Committee of the Whole Report

To: Committee of the Whole **Date:** November 12, 2020

From: Karen Hoese, Director, Sustainable Planning and Community Development

Subject: **Development Permit with Variances Application No. 00130 for 1150 Cook Street**

East Elevation

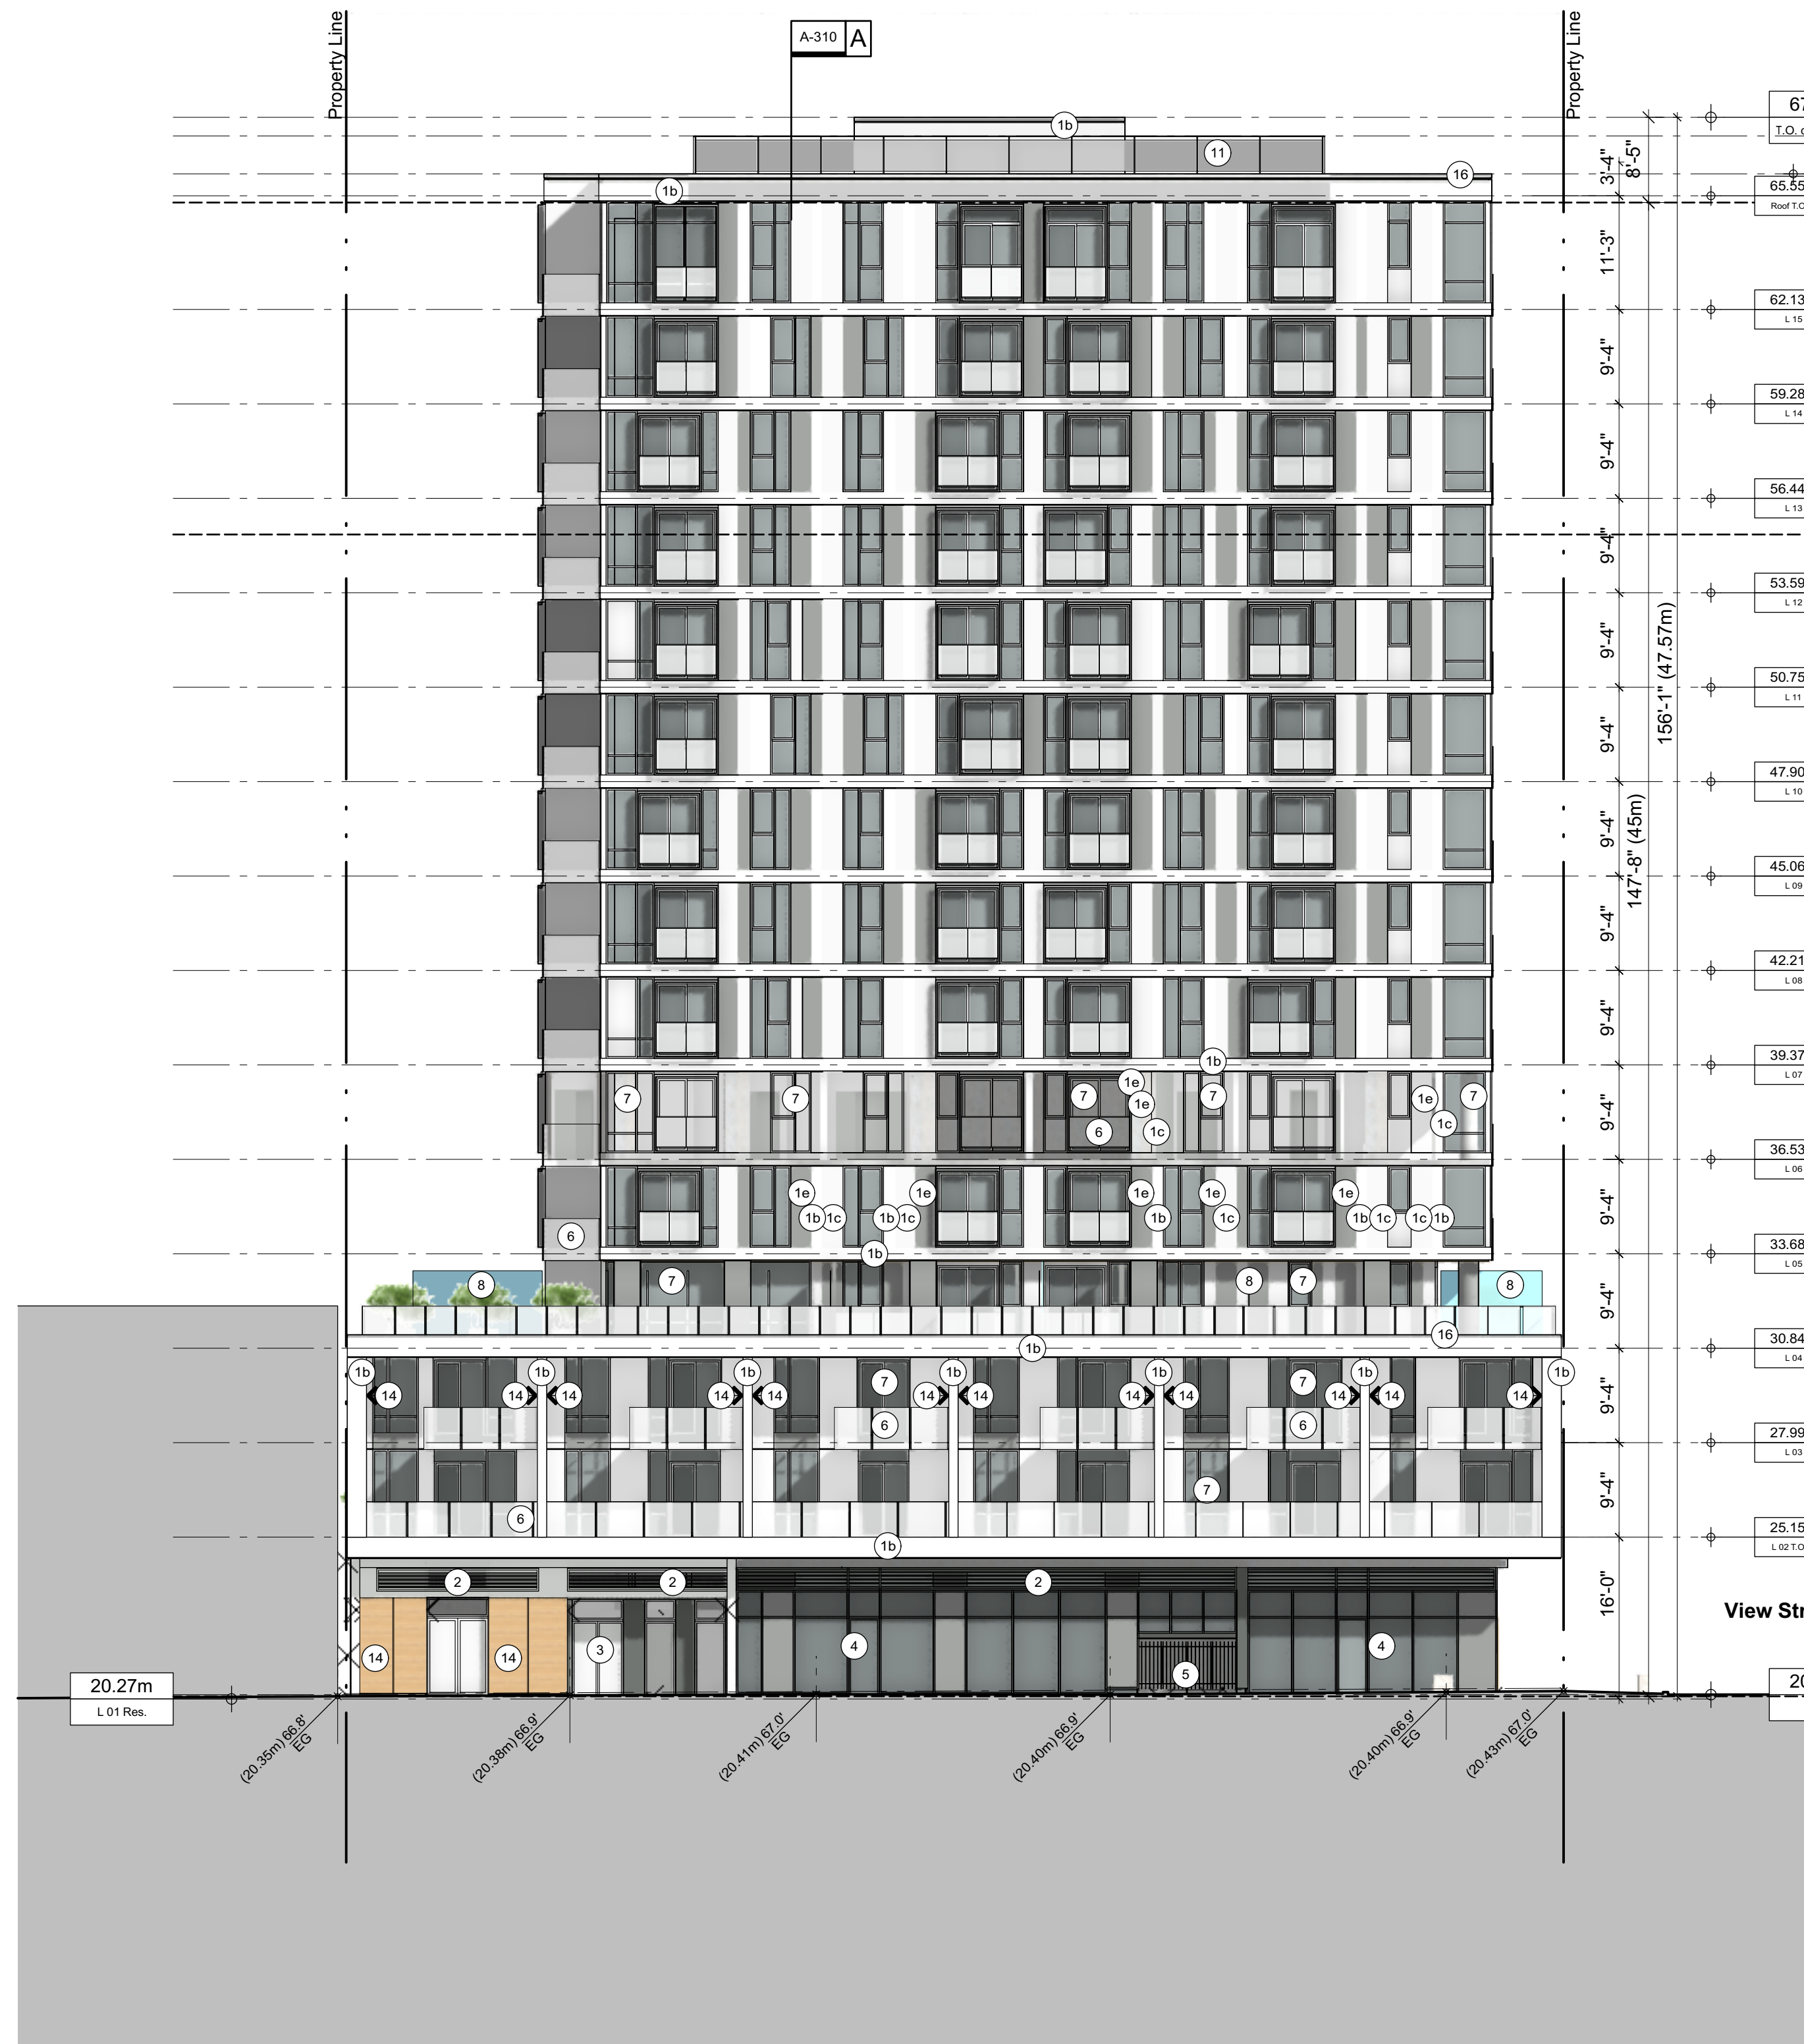
- a. Further consideration for the location of the gas meter on Cook Street and provision of additional detail for the design of the metal fence enclosure, to the satisfaction of the Director of Planning.

New buildings should be designed to relate well to public streets and sidewalks and have quality architectural materials and detailing in building bases and street walls. Staff have noted the limited and inconsistent detail provided on the architectural elevations, renders and material sheet, and recommend that these items be corrected prior to the application being considered for an Opportunity for Public Comment. In particular, the site plan indicates a gas meter that occupies a prominent location on the Cook Street frontage, with “decorative metal gates” but insufficient detail has been included on the elevations to fully review this aspect of the design. Staff recommend the location of the gas meter be reevaluated to ensure a positive street relationship along Cook Street.

Picture #4: The red line indicates the location of the balconies and the minimum amount of canopy loss. 60cm of clearance from the building would result in pruning cuts made at or behind the property line (blue line).

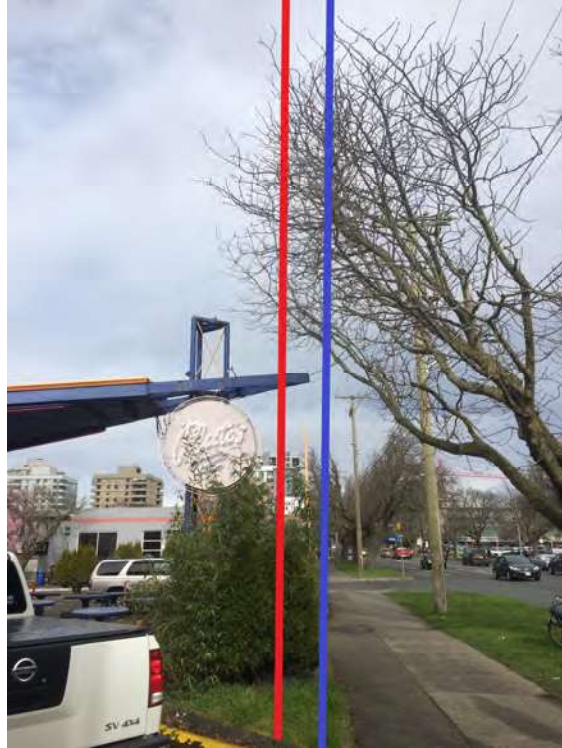
- e. Design revisions to reduce the impacts on the street trees along Cook Street, including reducing the pruning within the canopy and within the critical root zone to ensure the successful retention of these trees, to the satisfaction of the Director of Parks, Recreation and Culture.

There are two mature horse chestnuts on the Cook Street boulevard proposed for retention. The proposal, as currently shown, would require substantial pruning to the canopy of one large (70cm DBH) healthy horse chestnut tree growing on the Cook Street boulevard to construct the proposed building. The above-ground portion of the building is planned to have a setback of
